SI B11 12 12  
Engine

### N20 Engine: Engine Oil Filter Application

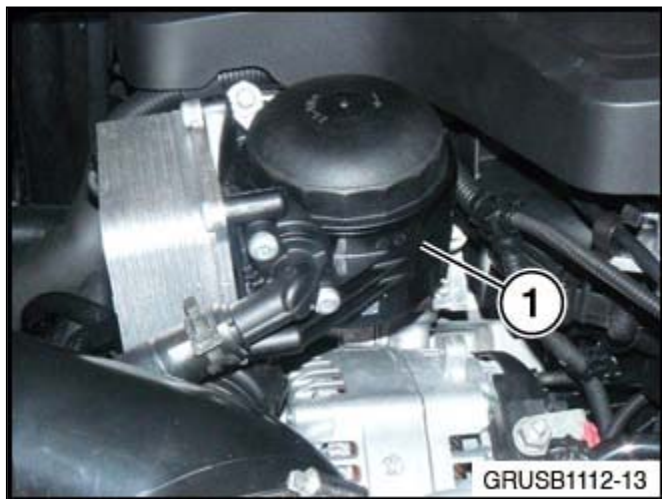
Vehicles produced prior to 6/2012 will be equipped with a black plastic oil filter housing (1).

Vehicles produced as of 6/2012 and later will be equipped with a silver aluminum oil filter housing (1).

In this case, engine oil filter kit P/N 11 42 7 634 291 should be used.

In this case, engine oil filter kit P/N 11 42 7 640 862 should be used.
